# INITIAL FIRE SAFETY INSPECTION REPORT

**Blue Planet Knitwear Ltd. (Extension)**

**RSC ID: 24508**

**Date: 28 March 2023**

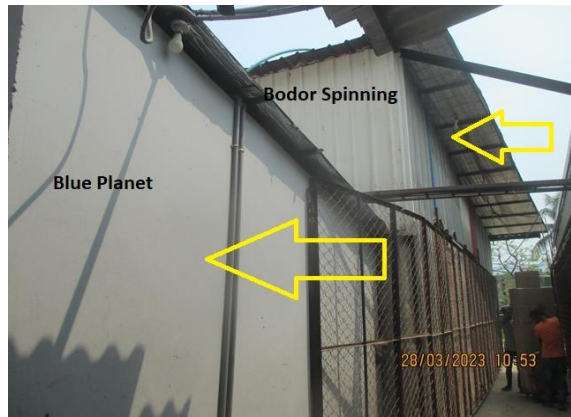
SI No.	Category	Findings	Required Action	Remediation Time Frame
F-1	Fire Rated Construction	The building is constructed in the interim period where the main structural element of the building is constructed by steel which is non-rated and were found in exposed condition without any fire protection.	The building shall be type-I or II construction. So, provide require rating in the structural elements of the building. Consult with a qualified fire protection engineer. Follow BNBC 2006-Table 3.3.1, 3.2.4 & 3.1.9.	Within 6 months
